## ADDENDUM #1

**Project:** Ogden-Hinkley Airport  
Remodel

**Project Number:** 2021-10

**Date:** 11.21.23

AE162

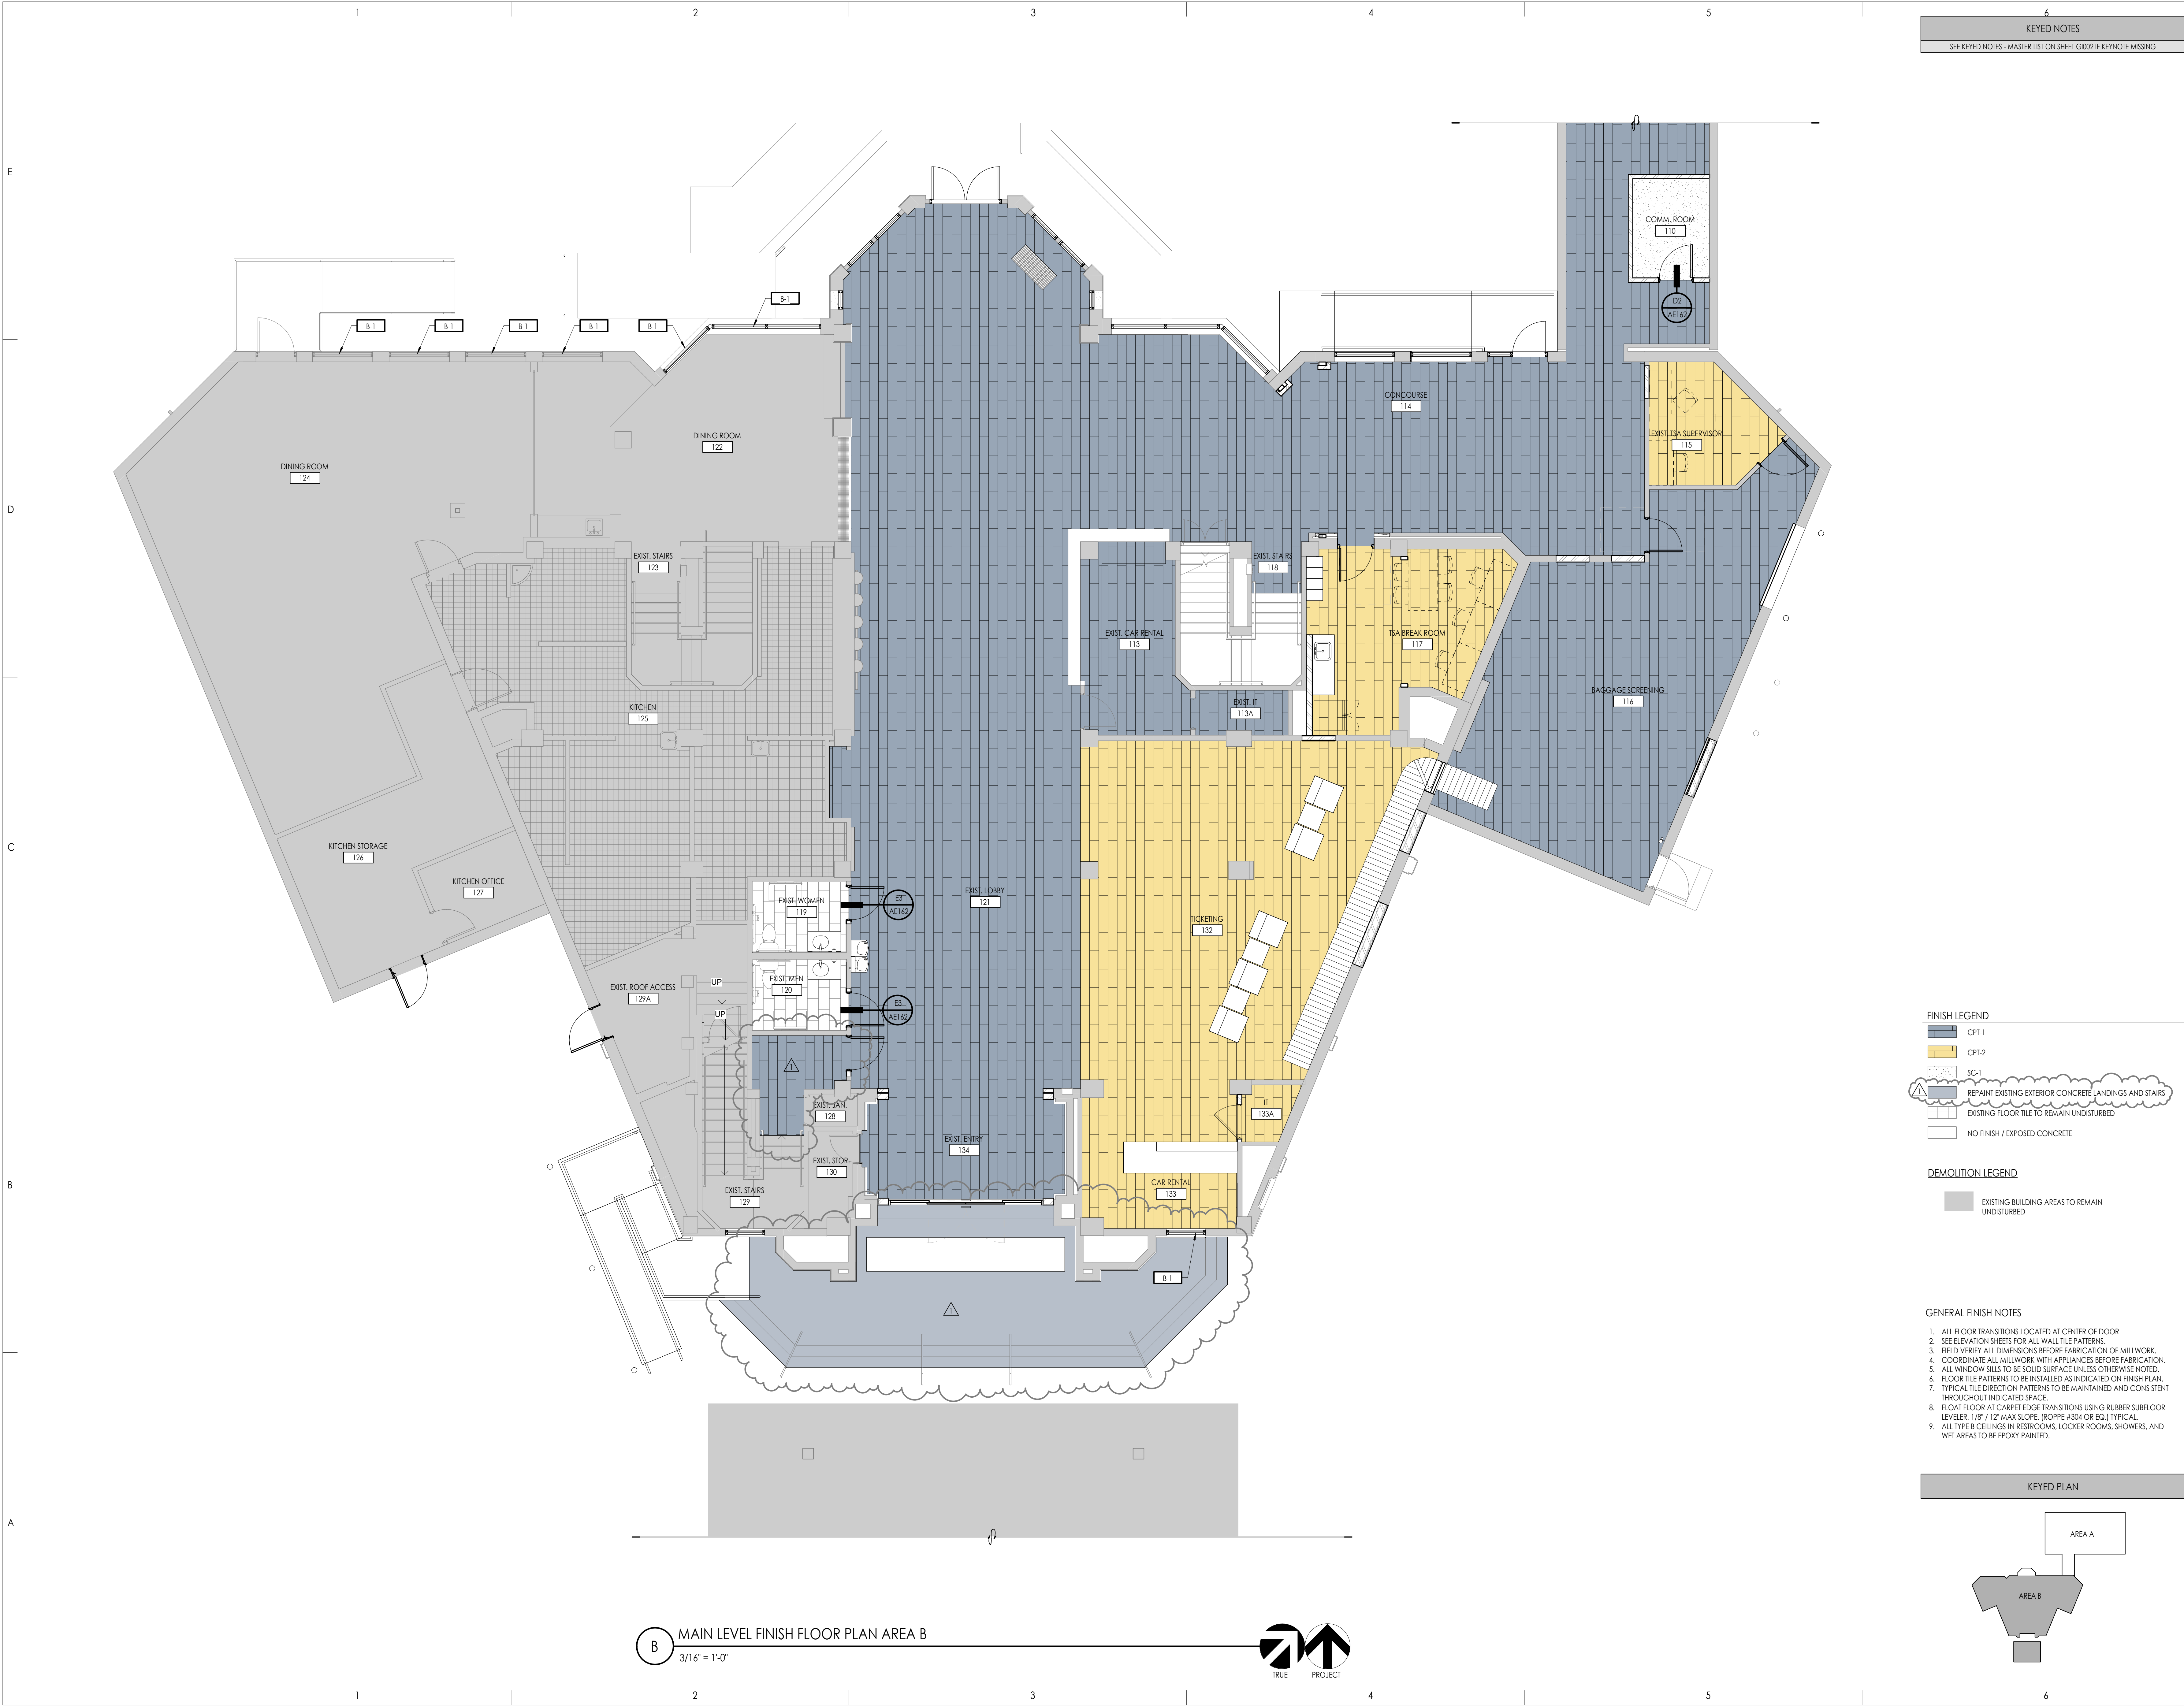
7. Drawing AE143:
  - A. Alternate #1, for removing the existing concrete column, is omitted. The work is to be included in the project.
  - B. Existing Stairs 129 ceiling is shown being repainted.
8. Drawing AE162:
  - A. Room Finish Schedule: Existing Stairs 129 is shown with new carpet, rubber base, repainted on walls and ceiling.
9. Drawing AE163:
  - A. Existing Stairs 129 upper landing area is shown with new carpet. New base will also be installed at the upper landing.
  - B. Existing exterior concrete landing and stairs is shown being repainted. Paint type to be determined to be compatible with existing paint.
10. Drawing AE601:
  - A. Door 108A is changed to a double door in the Door Schedule.

Sheet Number  
S201

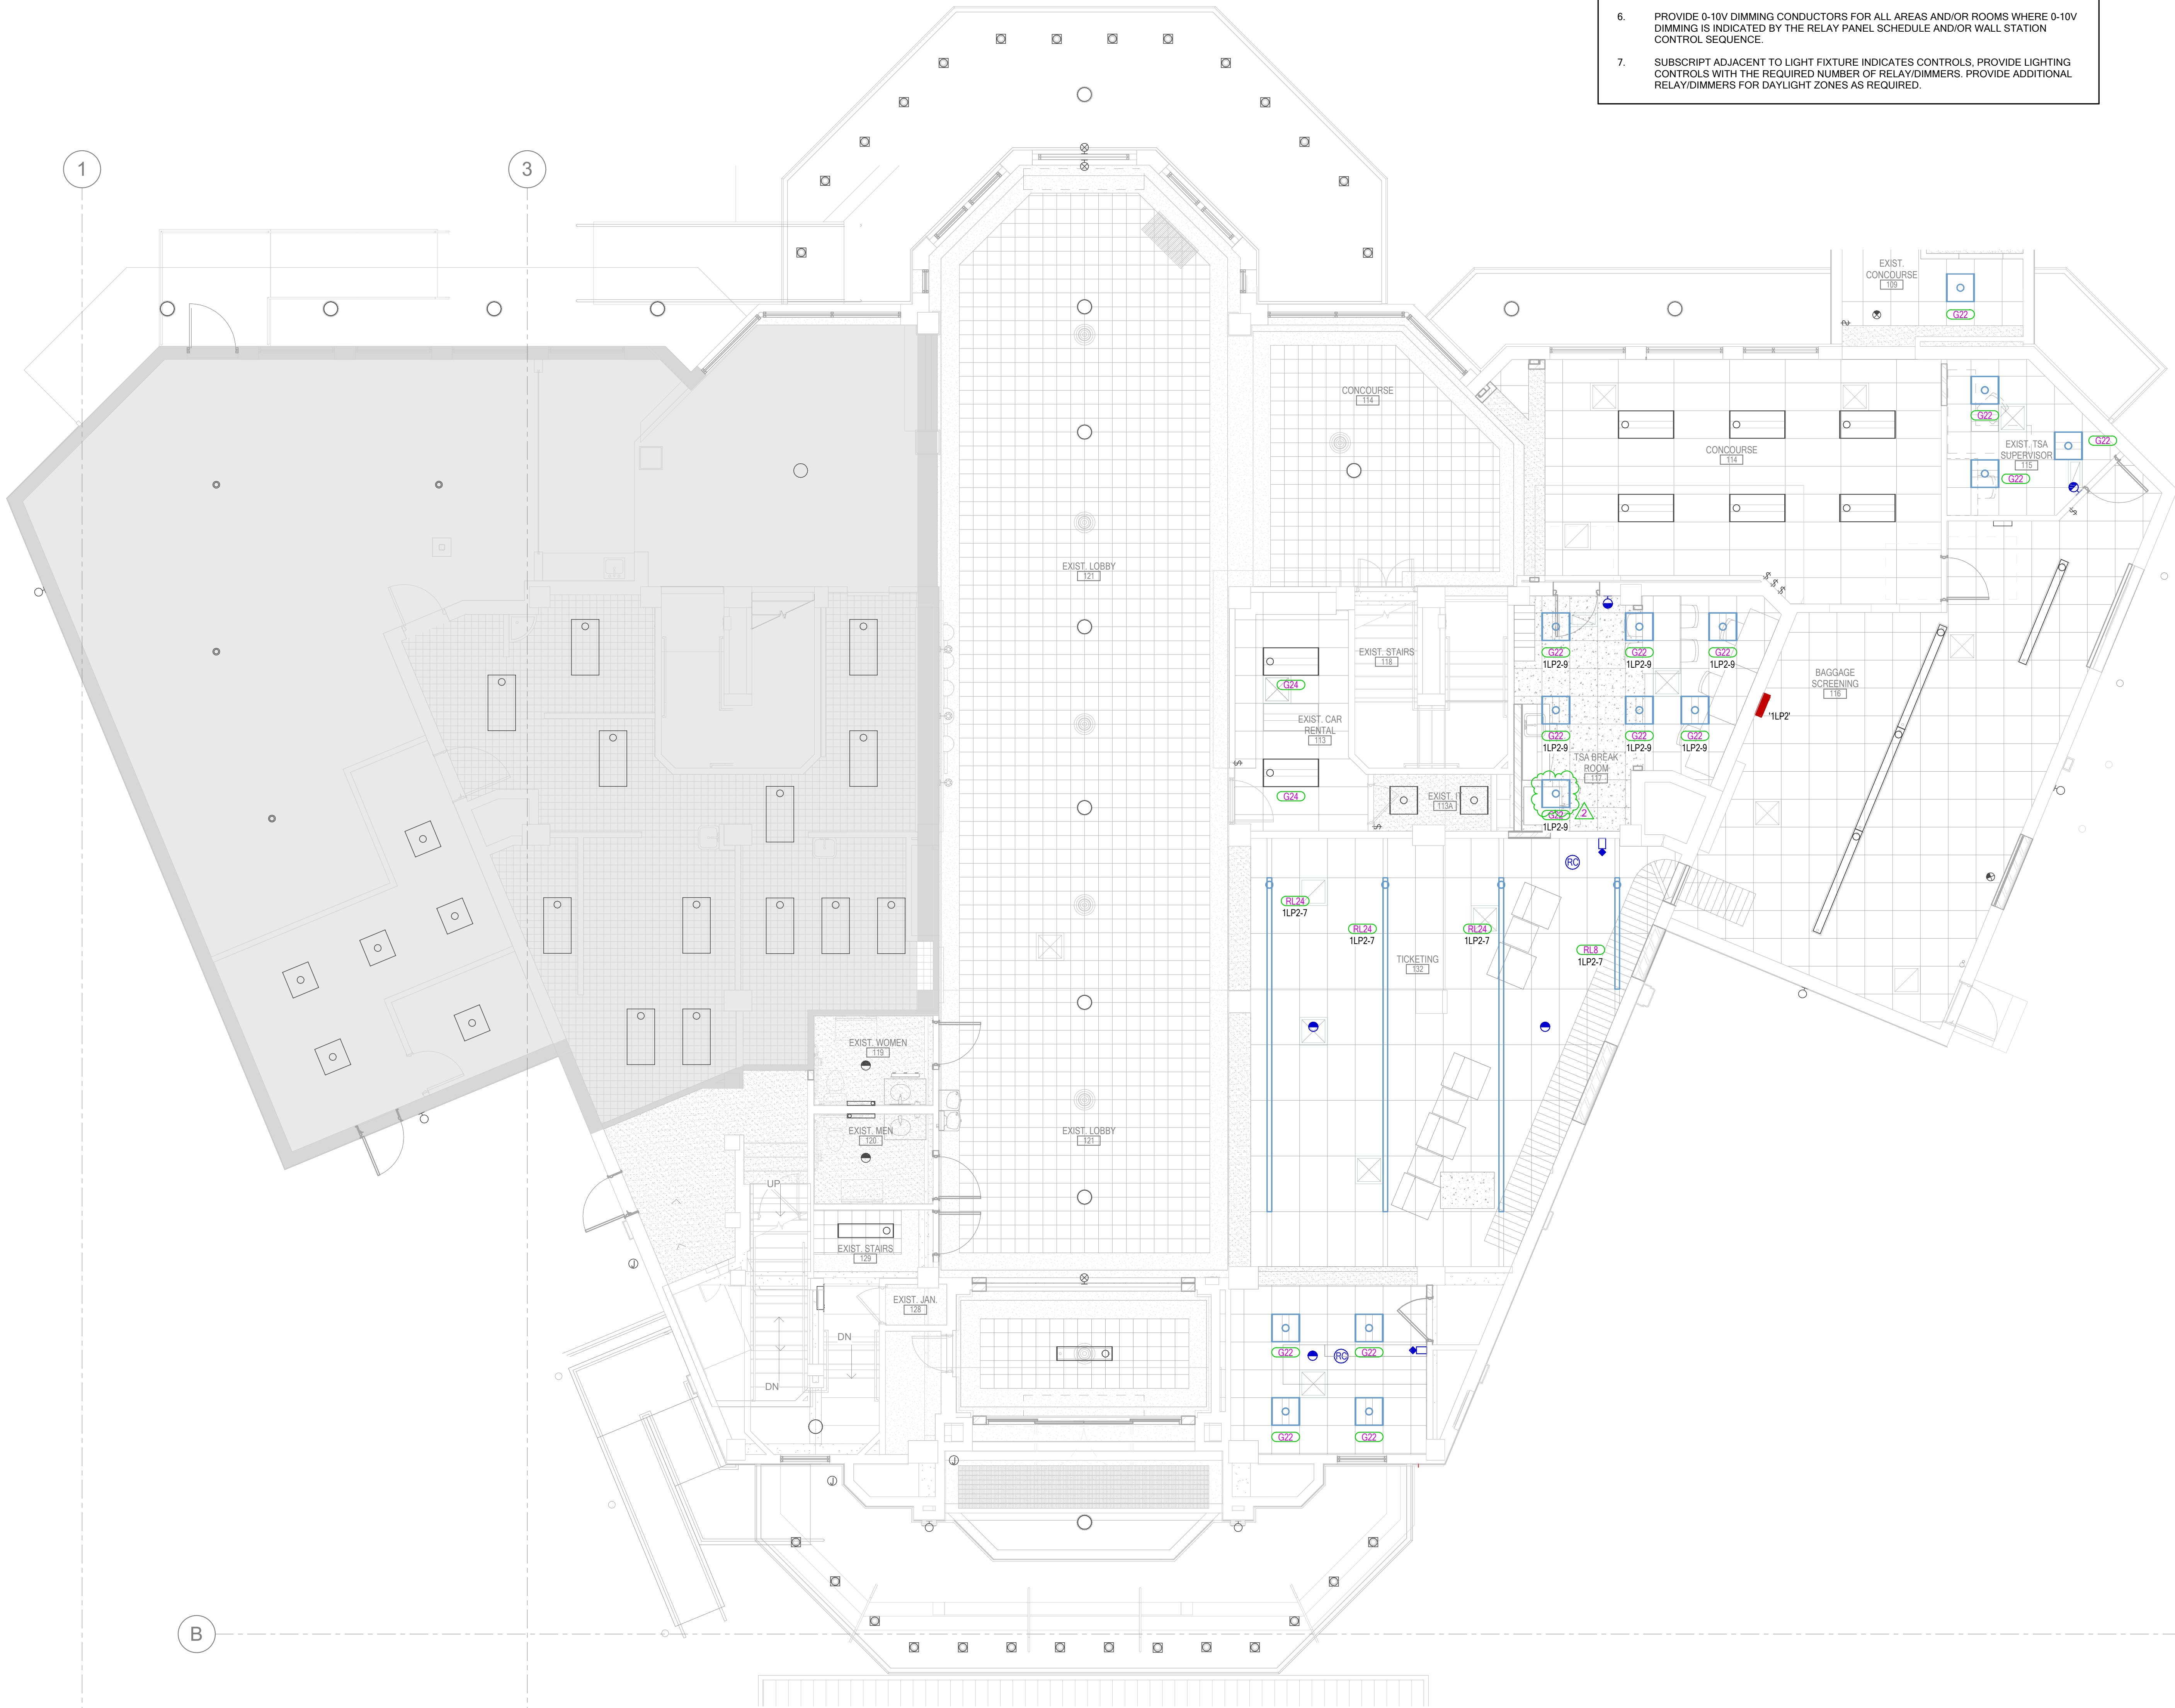
1. Drawing S101:
  - A. Note for the cutout for new door opening in wood framed wall added.
2. Drawing S102:
  - A. New wood header indicated for the cut-out opening in the existing wood framed wall.

LEVEL 1 - SYSTEMS PLAN  
- AREA A

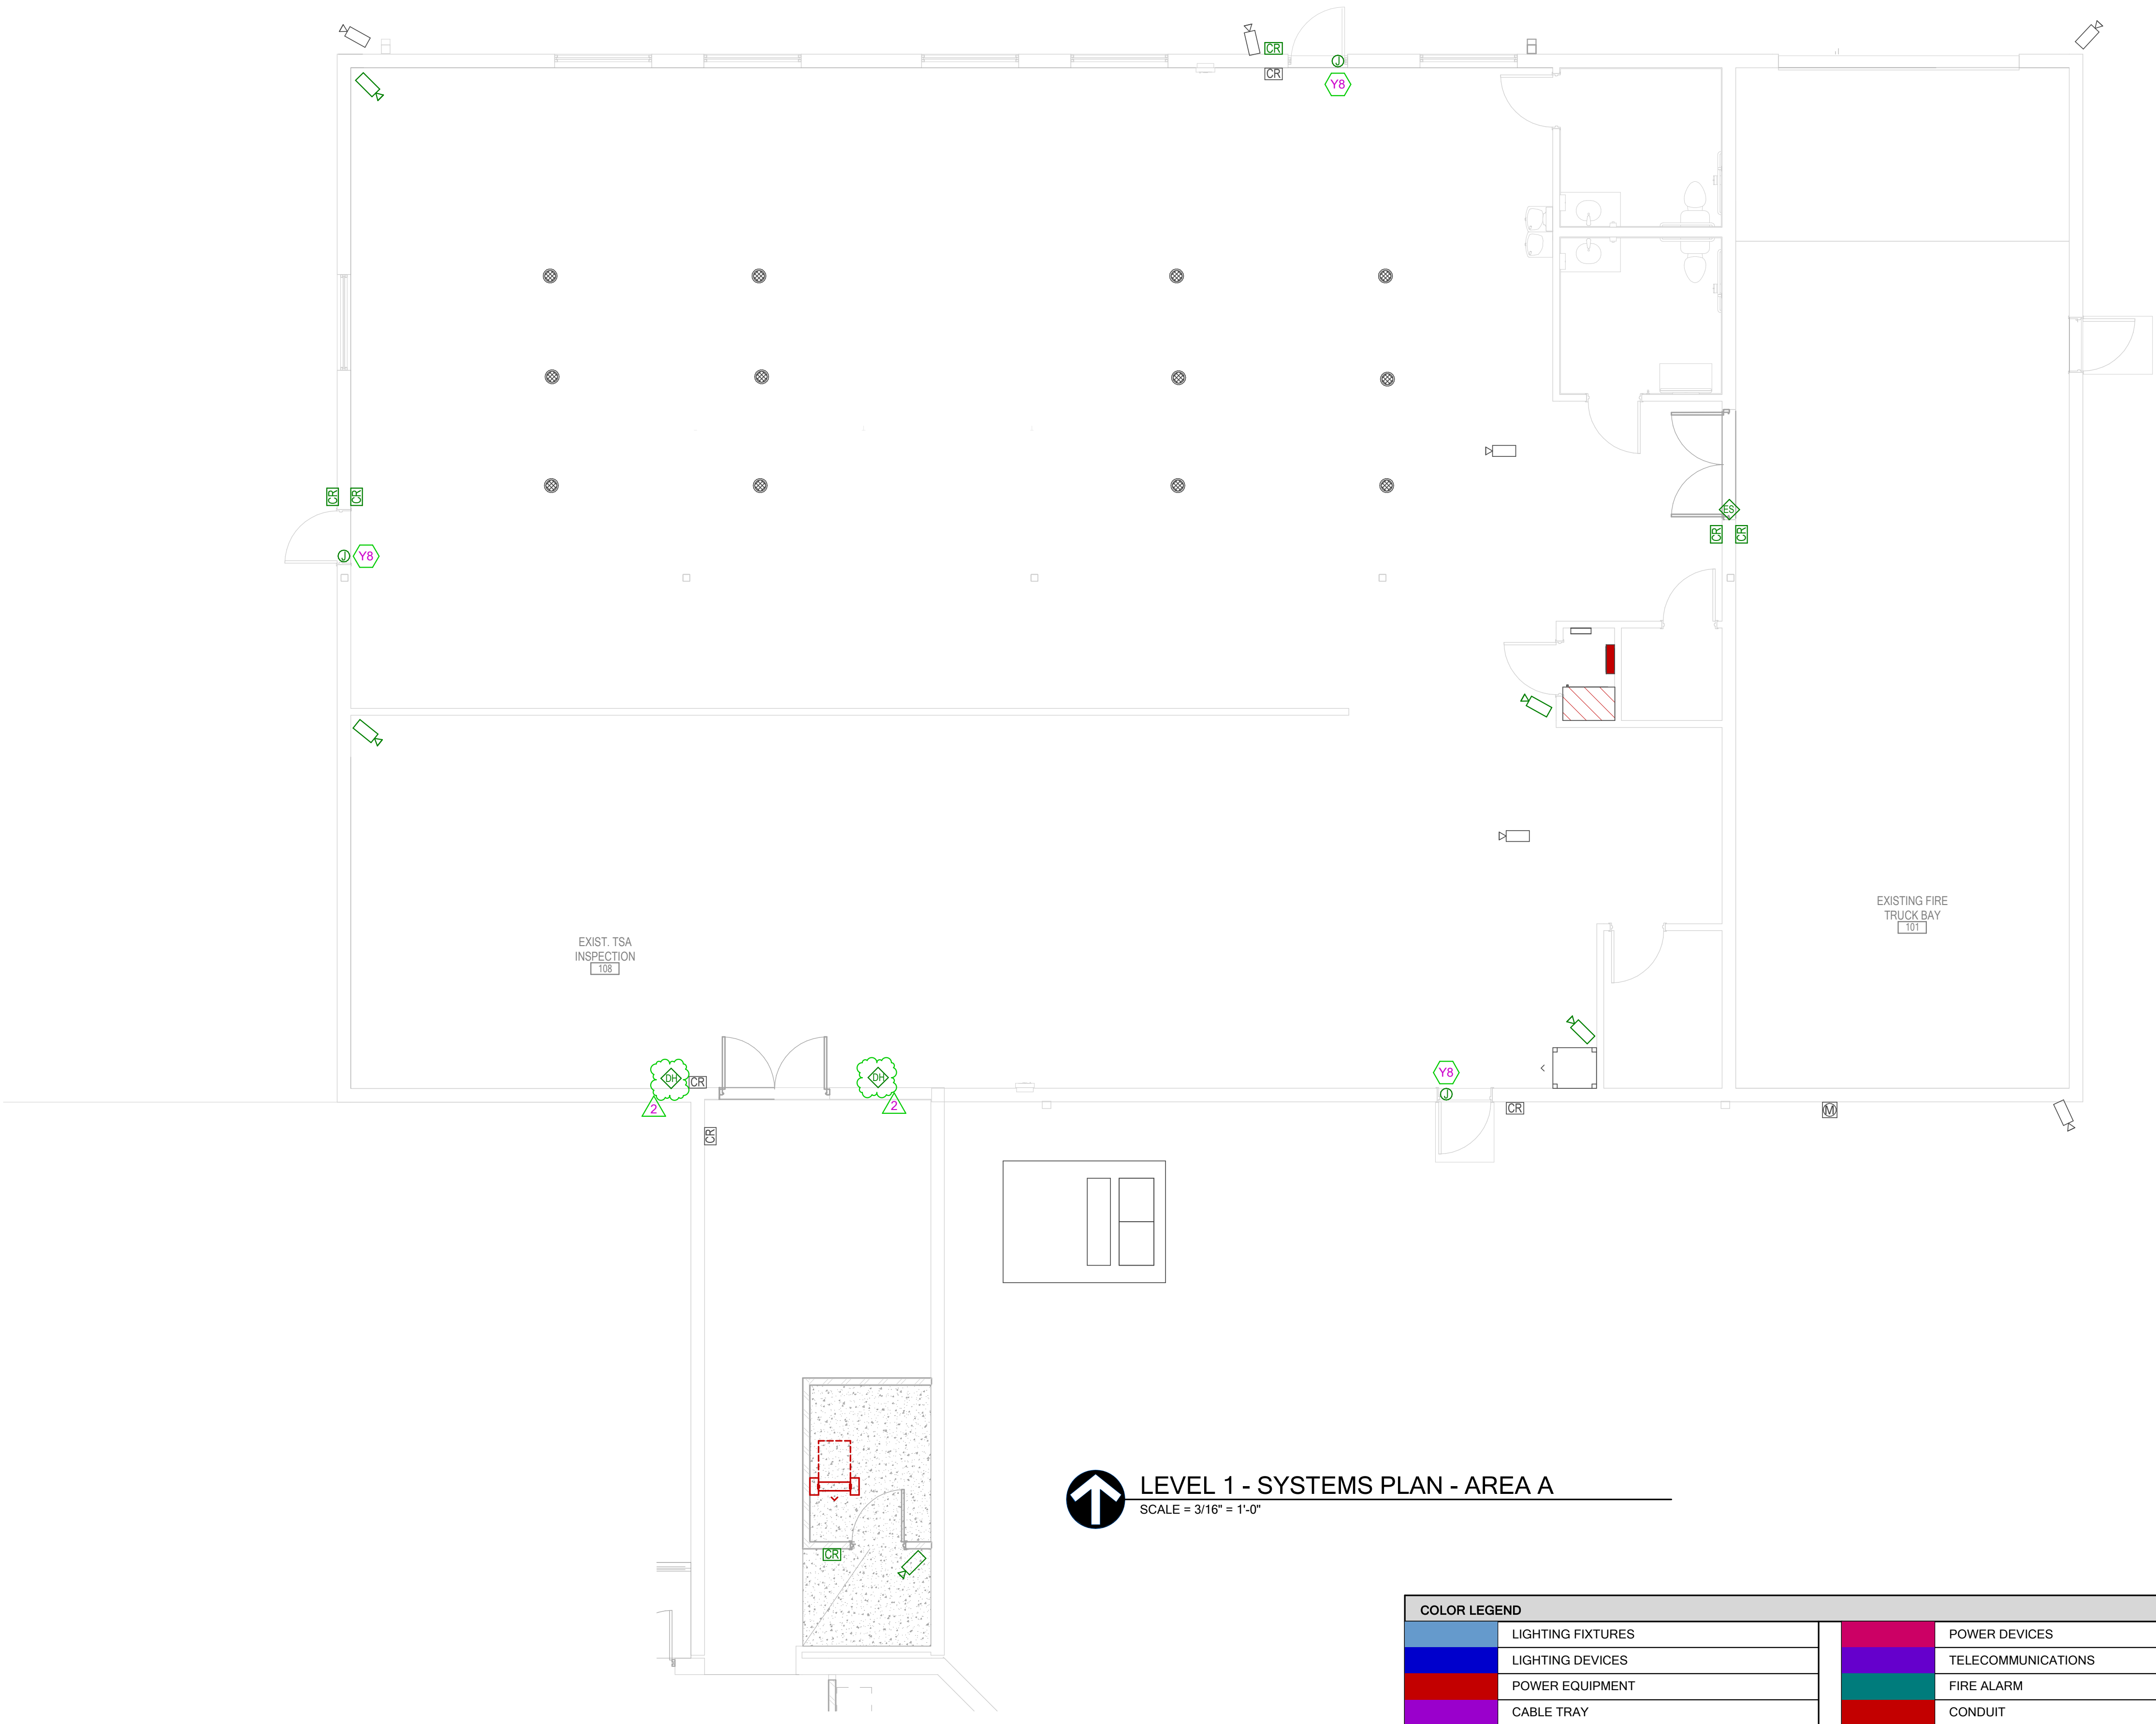
1. Drawing: E201B
  - A. Added a light fixture with tag (G22 1LP2-9) in TSA Breakroom 117.
2. Drawing: E401A
  - A. Added magnetic door stops and changed door hardware.
3. Drawing: ED510A
  - A. Removed receptacle that will be demolished with addition of double door.
